GEORGETOWN-SCOTT COUNTY PLANNING COMMISSION

**AGENDA
JUNE 13, 2024
6:00 p.m.**

**GOLF TOWNHOMES OF CHERRY BLOSSOM PHASE 7
PRELIMINARY SUBDIVISION PLAT & DEVELOPMENT PLAN**

**Staff Report to the Georgetown-Scott County Planning Commission
June 13, 2024
(postponed from 05/09/2024)**

PRELIMINARY SUBDIVISION PLAN
 GOLF TOWNHOMES OF CHERRY BLOSSOM
 PHASE 7
 GEORGETOWN, SCOTT COUNTY, KENTUCKY

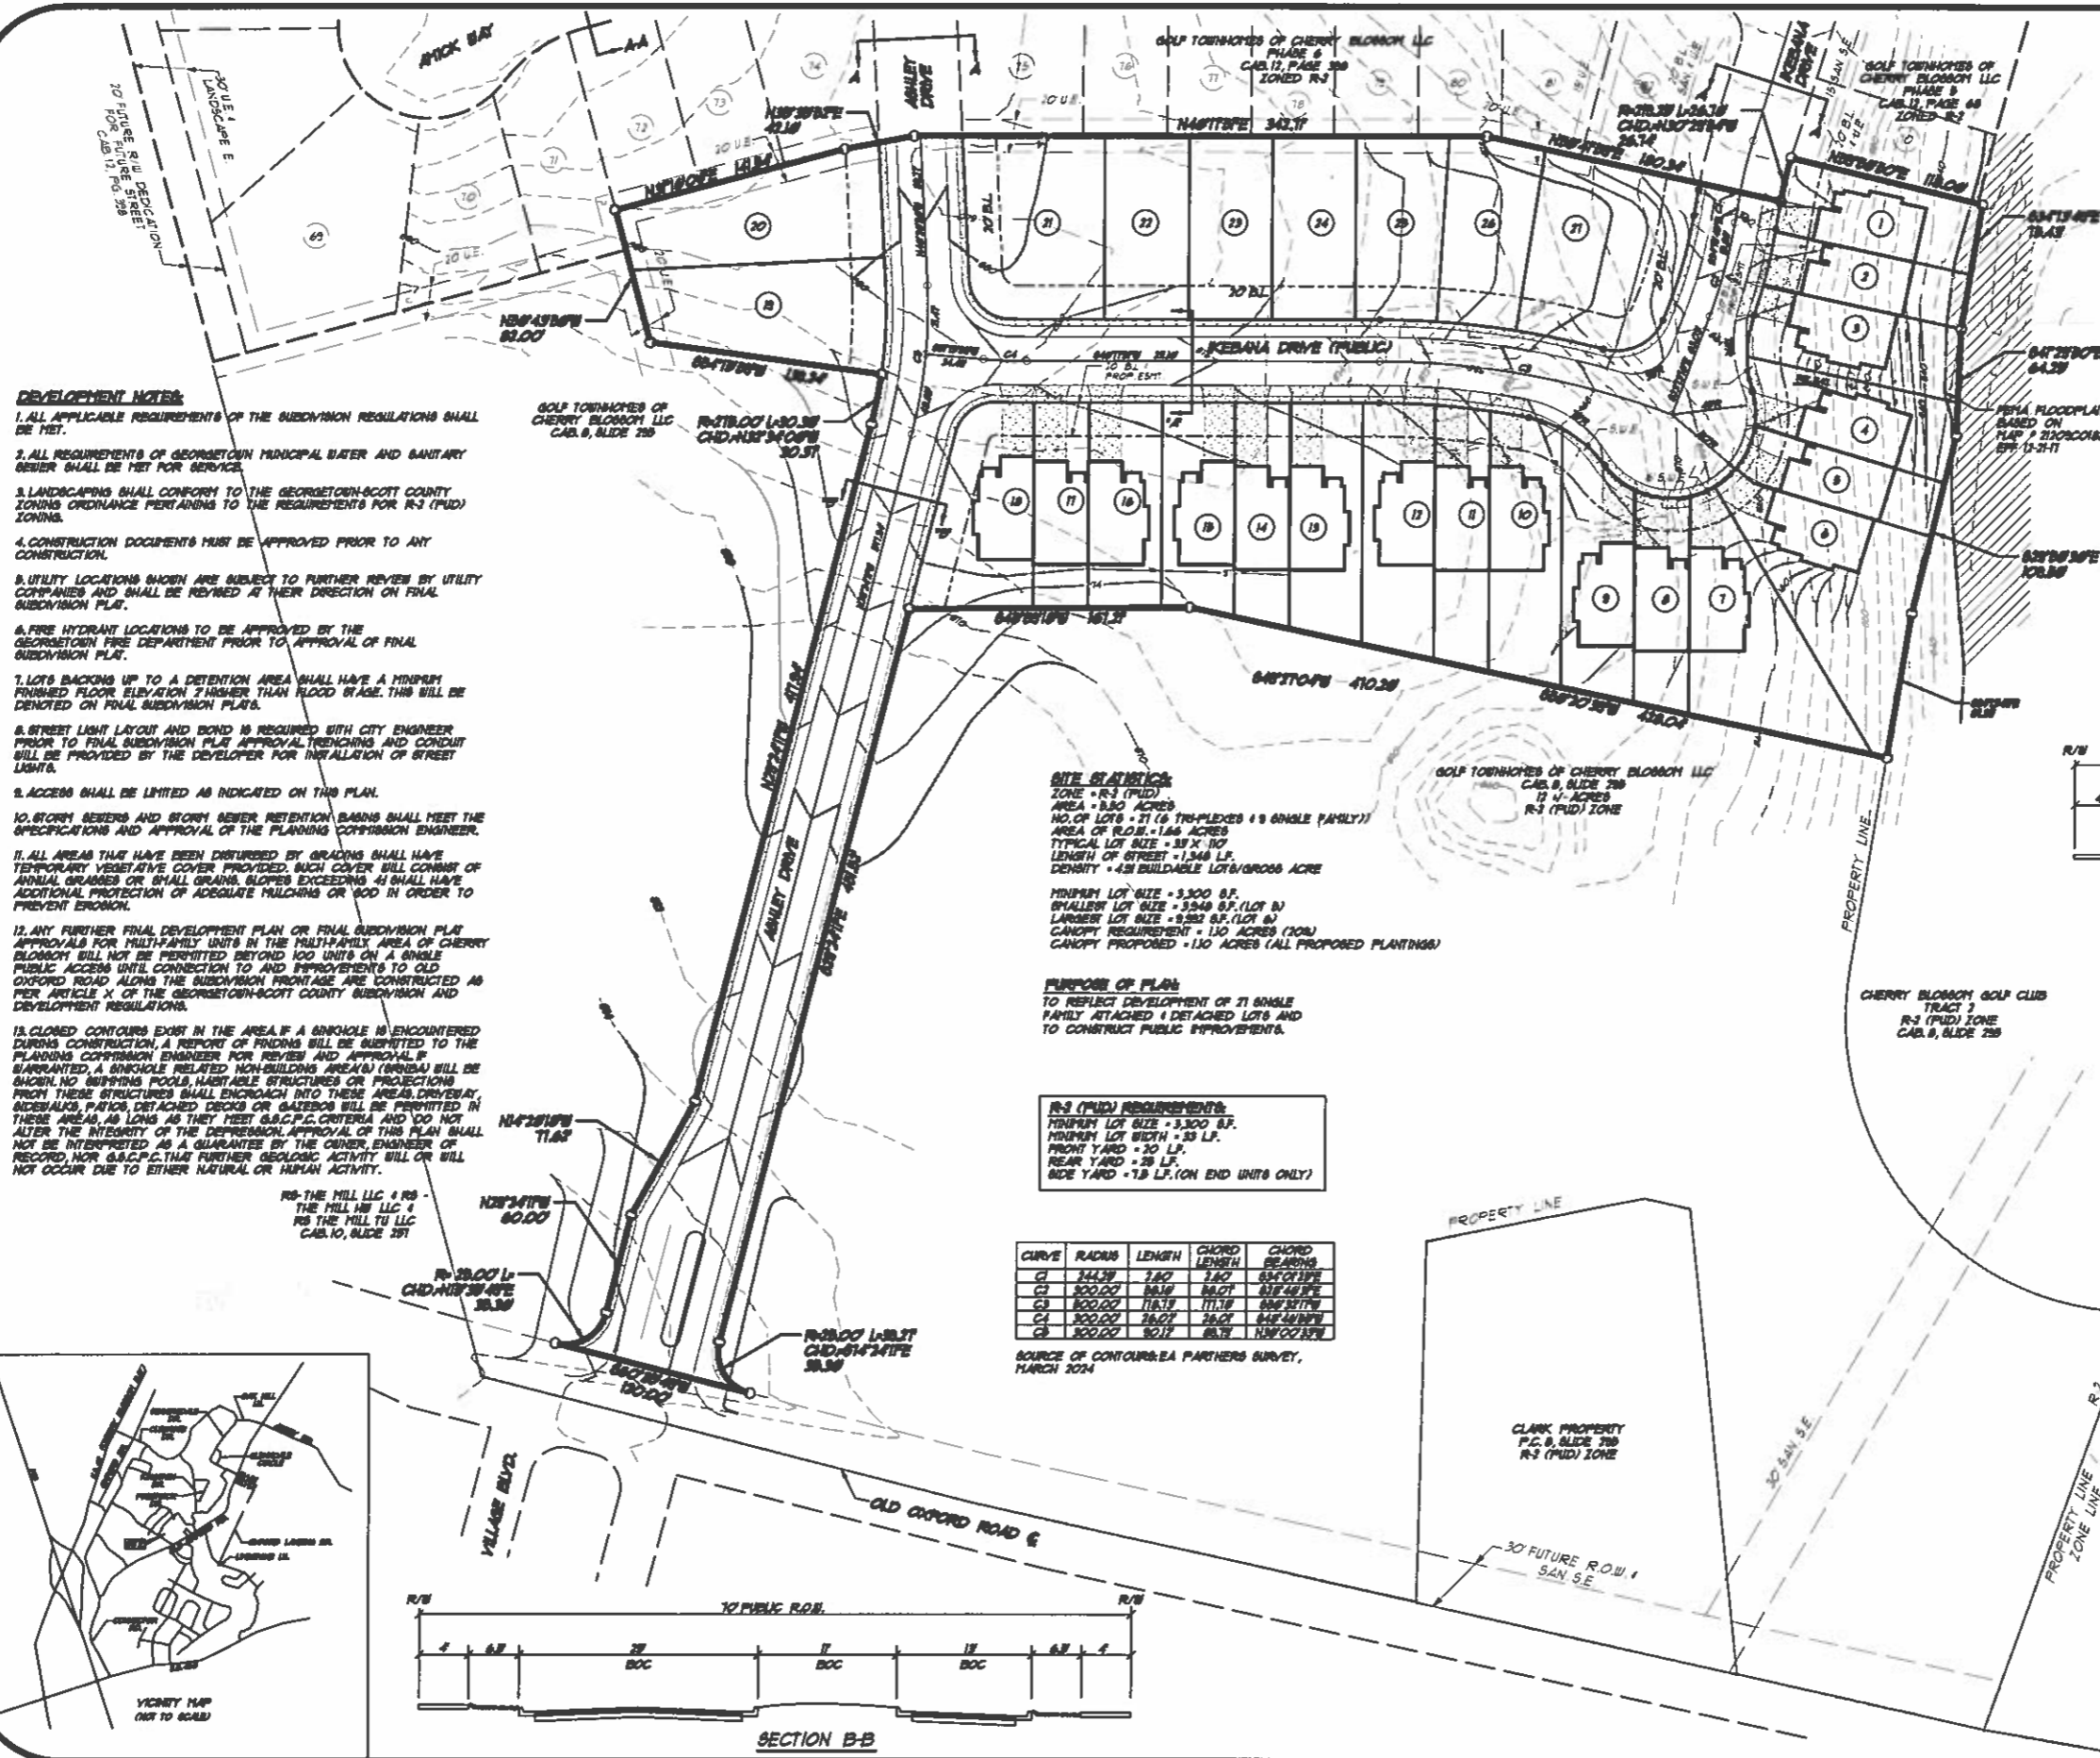
After review of the amended plan, the lot and road layout proposed in phase 7 is more conducive to satisfying the requirement to connect to Old Oxford Road than previous versions. Having an alternative exit onto a less congested area would alleviate the pressures of the Cherry Blossom Way and Connector Road intersections.

The improvement of and connection to Old Oxford Road is essential for needed road connectivity for emergency services and to allow for local traffic dispersion in the area. Staff does not support approval of this application without the condition that the connection to Old Oxford Road and improvements (including widening) of Old Oxford Road be made prior to approval of the final plat or development plan for the property. By requiring completion of roadway improvements prior to subdivision or development, construction traffic can be directed away from the existing community, reducing traffic through the neighborhood to the phase 7 area.

The typical single-family detached lots are on average 50-feet-wide and 105-feet-deep (5,250 sq. ft.) and the typical single-family attached lots are on average 33-feet-wide and 110-feet-deep (3,630 sq. ft.). Phase 7 is proposed to have an average of 7.301 dwelling units (DU) per net acre or 4.91 DU per gross acre. This is consistent with the requirements established at the zone change and previous attached residence phases of the development. The smallest lots of phase 7 are the central units in the single-family attached area, with the smallest of these being 3,948 SF (lot #5).

Floodplain is shown in the rear property lines of lots 1-4, and near the rear property lines for lots 5 & 6. The grading plan also shows some steep slopes proposed for lots 1-6, with an estimated grade change

The Applicant has not yet adequately addressed how stormwater quality and quantity will be handled with this development. Previous phases of the multi-family development had stormwater being handled through an area wide stormwater plan and easements, but no connections to the plan and easements are shown on this plan. The stormwater management plan shall be approved by the Planning Commission Engineer. A homeowners' association will be required for the maintenance of common areas and facilities.

The number of bedrooms dictates the minimum number of off-street parking spaces required in a residential development. The proposed plan identifies four (4) off-street parking spaces per townhome unit. Per the *Subdivision and Development Regulations*, a one (1) bedroom townhome residence requires two (2) off-street spaces and a two (2) or three (3) bedroom townhome residence requires 2.5 off-street spaces. Each unit appears to have a garage and driveway combination, which can be credited for 2 off-street parking spaces of the 2.5 spaces required for the residence type. If the garages are two-car construction, the combination of garage and driveway can be credited for 4 off-street parking spaces.

The proposed plan does not state the number of off-street parking spaces for the single-family detached residences. Per the *Subdivision and Development Regulations*, a two (2) or three (3) bedroom residence requires two (2) off-street spaces and a four (4) to five (5) bedroom residence requires three (3) off-street spaces. The final development plan shall indicate the number of the number of bedrooms in a single-family detached residence and include appropriate off-street parking accommodation.

Staff recommends **Approval** of the Preliminary Subdivision Plat & Development Plan for the Golf Townhomes of Cherry Blossom Phase 7 with the following variances, waivers and conditions of approval:

**WOODLAND AIRSTREAM PROPERTY SUBDIVISION
PRELIMINARY SUBDIVISION PLAT**

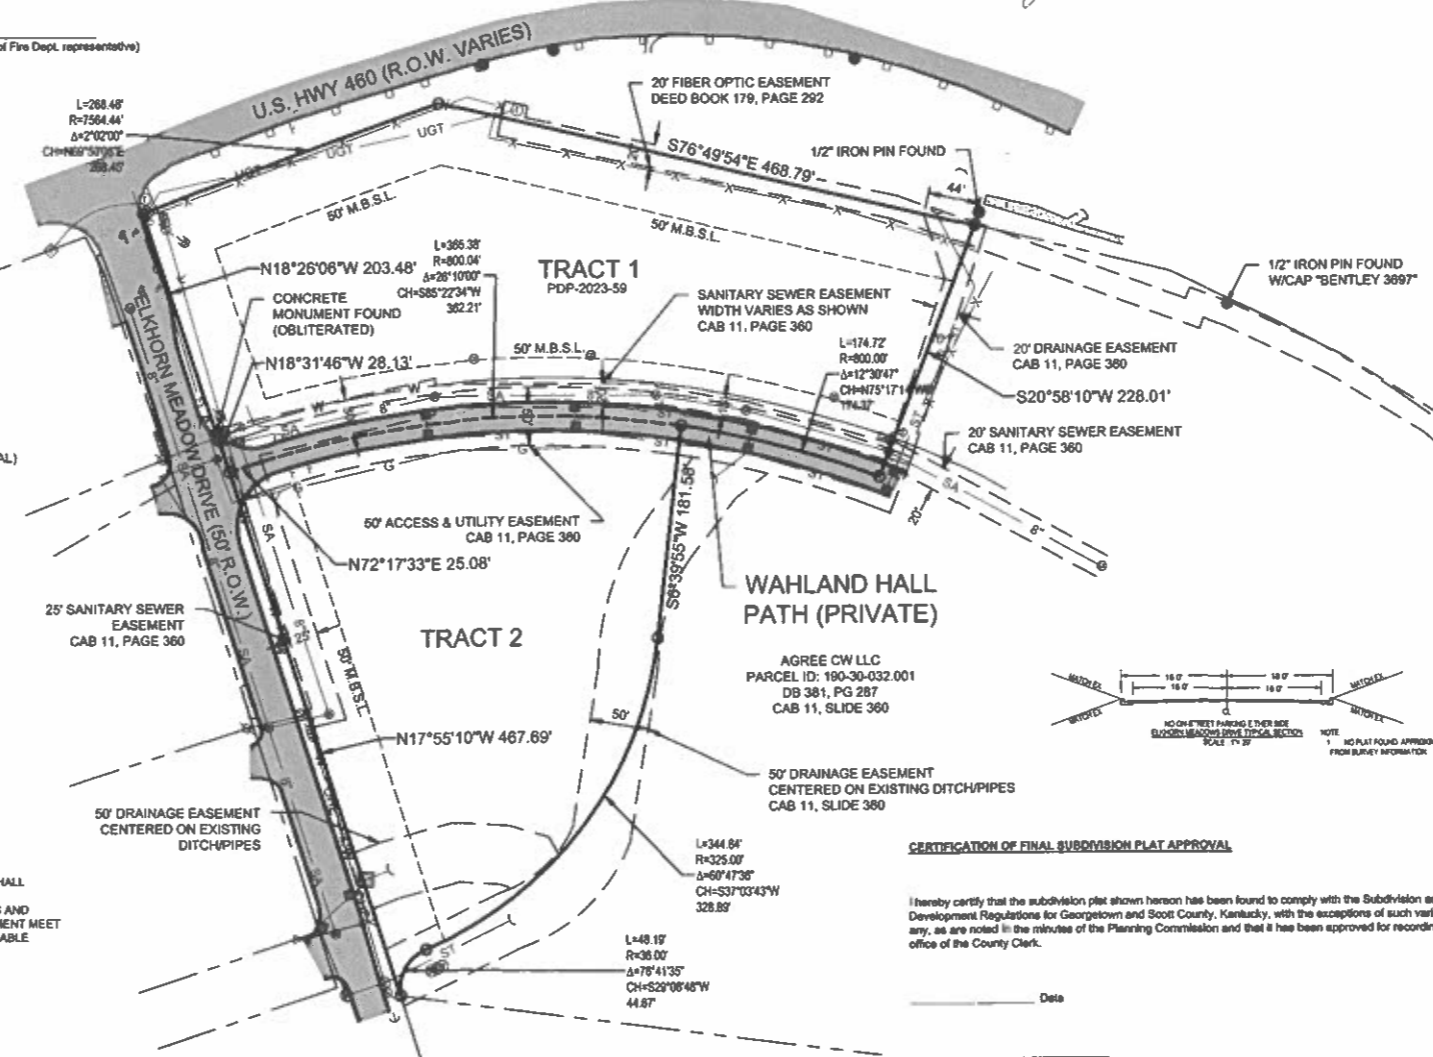
The proposed lots will both be accessed from Wahland Hall Path, a privately maintained road. Maintenance of the road would be the responsibility of the users of the road. The lots meet the minimum lot size, width, and setbacks for the B-2 zoning district. All utilities providers will be required to sign the final plat, and the Applicant will need to verify that all proper utility easements are shown prior to signing the final plat.

Staff recommends the Planning Commission recommend **Approval** of the Preliminary Subdivision Plat. Should the Planning Commission recommend approval, staff suggests adding the following conditions of approval.

C.1
PRELIMINARY DEVELOPMENT

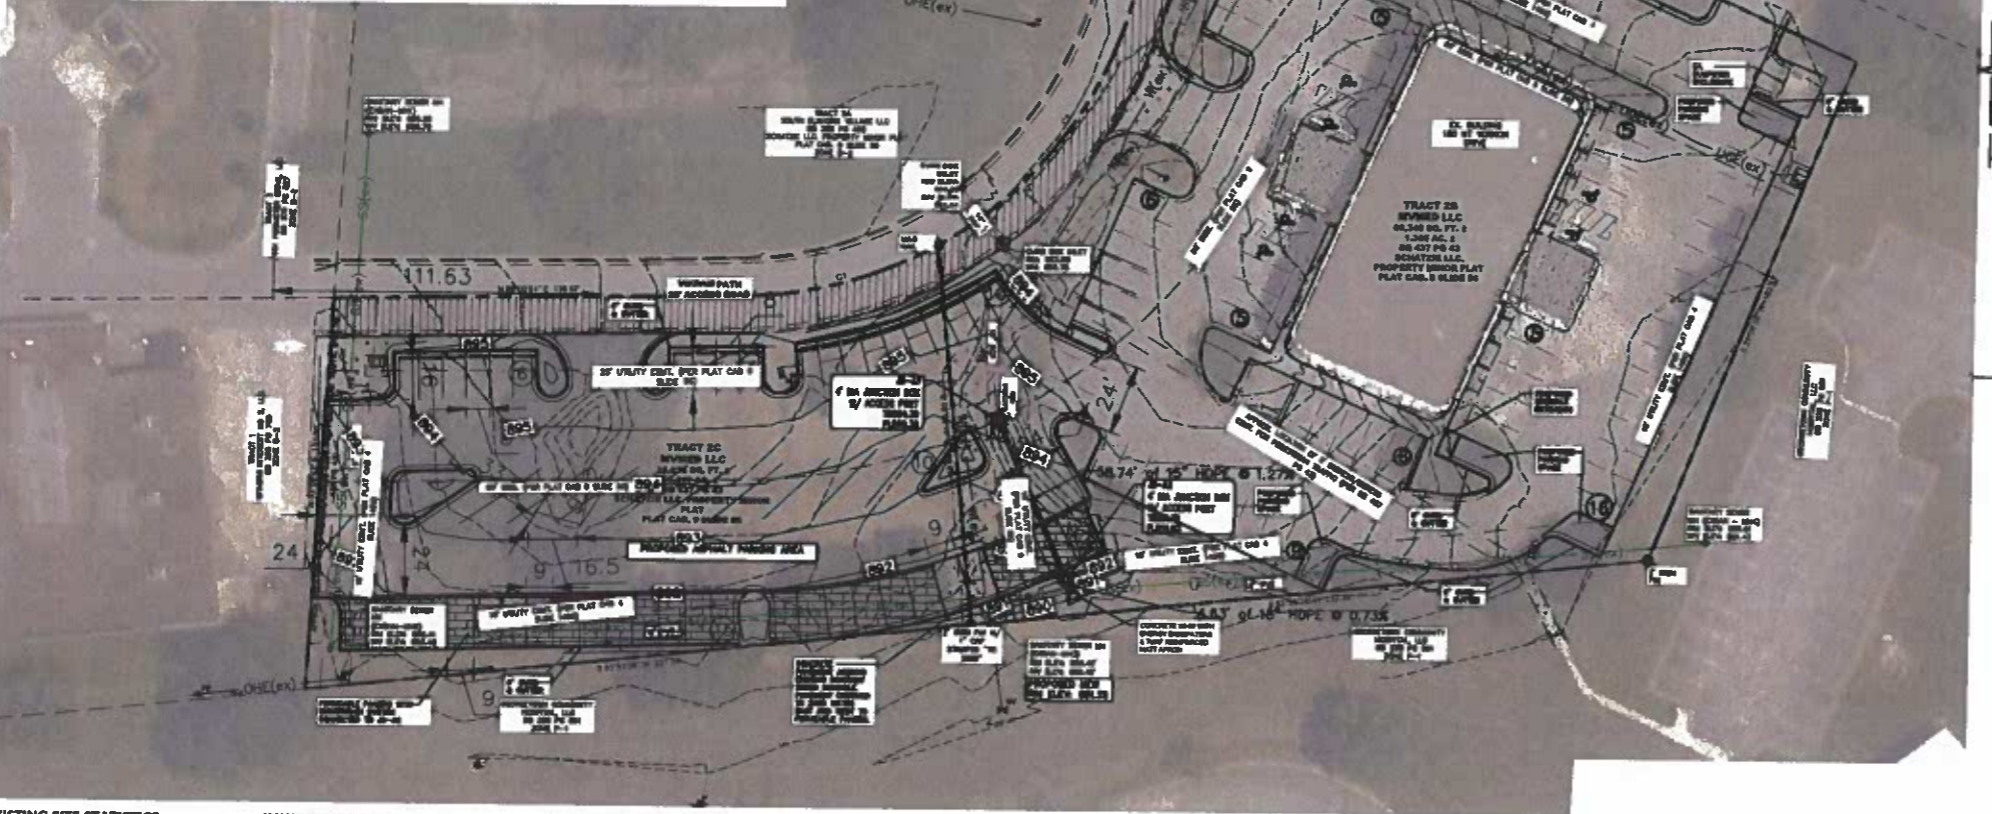
The development plan proposes two parking / VUA additions. An additional 5,264.30 sq. ft. will be added to the currently developed parcel (Tract 2B), and 19,624.6 sq. ft. will be created on a vacant adjacent parcel (Tract 2C).

The Project Site is accessed by existing entrances from Mt. Vernon Drive and Vikram Path. The Applicant proposes a new entrance off Vikram Path onto Tract 2C. This new entrance/exit will provide easier, safer access to the site with multiple avenues of ingress/egress for general traffic and emergency services.

The proposed development plan indicates only the minimum required parking spaces (126) are being supplied. Staff does have concerns that an increase in number of employees or exam rooms in the building, or an unexpected volume of use for the currently unoccupied first floor may create a greater need for parking than is currently proposed. However, at the time of staff report writing, there is no proposed user for the first floor, though the Applicant has indicated they will supply documentation to notify any prospective tenant of the limitations.

6. A Final Stormwater Management Plan must be submitted and approved by the Planning Commission Engineer prior to approval of the Final Development Plan. Development must meet all requirements of the Georgetown Stormwater Manual.
